Project	IEEE 802.16 Broadband Wireless Access Working Group < http://ieee802.org/16 >	
Title	A common preamble sequence for OMI identification and for FFT sizes other than 2048	
Date Submitted	2004-08-24	
Source:	<p>Jason Hou, Jing Wang, Sean Cai, Dazi Feng, Yonggang Fang</p> <p>ZTE San Diego Inc. 10105 Pacific Heights Blvd. San Diego, CA 92121 USA</p>	<p>Voice: +82-31-279-3355 jiho.jang@samsung.com wonil.roh@samsung.com sjmaeng@samsung.com panyuh@samsung.com jhjeon@samsung.com soon.young.yoon@samsung.com seongwook.song@samsung.com</p> <p>Voice: 858-554-0387 Fax: 858-554-0894 jhou@ztesandiego.com jwang@ztesandiego.com scai@ztesandiego.com dfeng@ztesandiego.com yfang@ztesandiego.com</p>
Re:	IEEE 802.16e D4 Draft	
Abstract	Addition of a common SYNC symbol to aid in fast cell search.	
Purpose	To incorporate the changes here proposed into the 802.16e D5 draft.	
Notice	This document has been prepared to assist IEEE 802.16. It is offered as a basis for discussion and is not binding on the contributing individual(s) or organization(s). The material in this document is subject to change in form and content after further study. The contributor(s) reserve(s) the right to add, amend or withdr

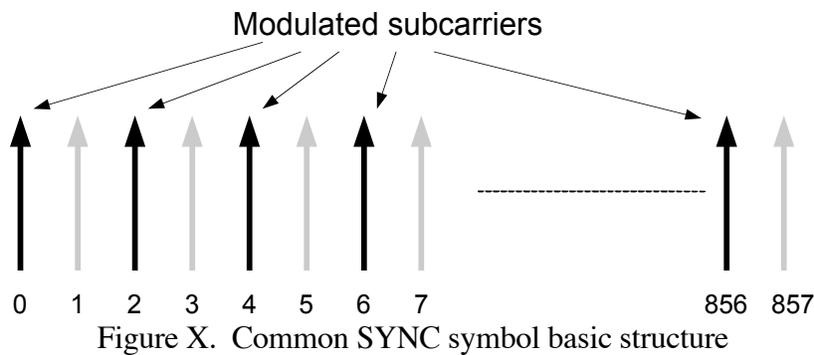
The common SYNC symbol modulates each 2nd subcarrier with modified CAZAC sequences and uses legacy preamble boosting formula described in 8.4.9.4.3.1. Figure X depicts an example of the subcarrier modulation.
